ANN ARBOR DESIGN REVIEW BOARD STAFF REPORT

MEETING DATE: December 13, 2023

PROJECT: 228 Packard, Project No. DR23-0004

Figure 1: Proposed Site Location

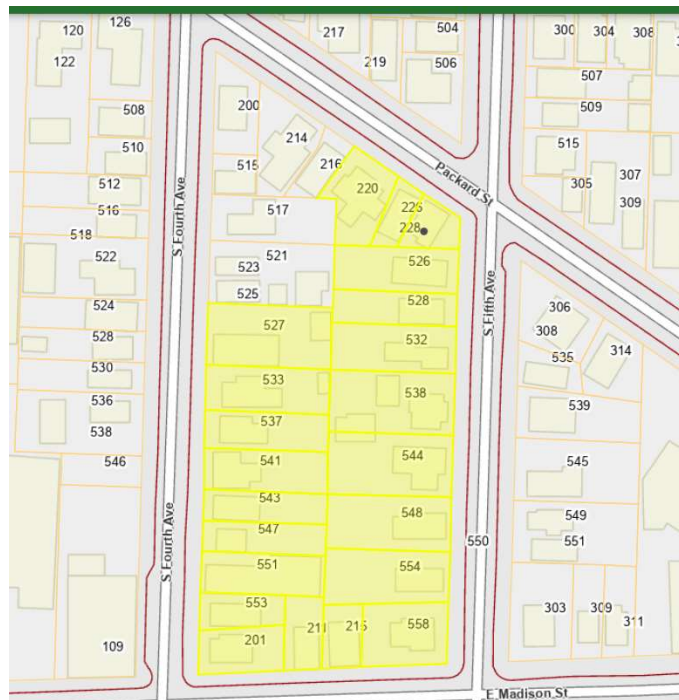
- c. Based on the established and emerging character of the area within three blocks of the site in all directions, it is staff's opinion that the proposed project is not in keeping with its surroundings. The design and mass are not consistent with the intent of the proposed First Street Character area, which is characterized by "oddly-shaped blocks and a mixture of commercial storefronts, industrial buildings, and single-family homes." It is also not consistent with a dense, near-downtown residential neighborhood, or even a traditional campus style. Both the design and the building mass are more appropriate to the downtown core, perhaps as befitting the proposed rezoning, but not befitting the actual setting.

- d. Some required dimensional standards have not been met, particularly the required offset at the top of the streetwall and massing articulation. It would be especially appreciated if the rhythm of the underlying lots could be visibly reflected in building design as a way of breaking up large, flat facades that provides little reflection or relationship to the surrounding land use patterns.
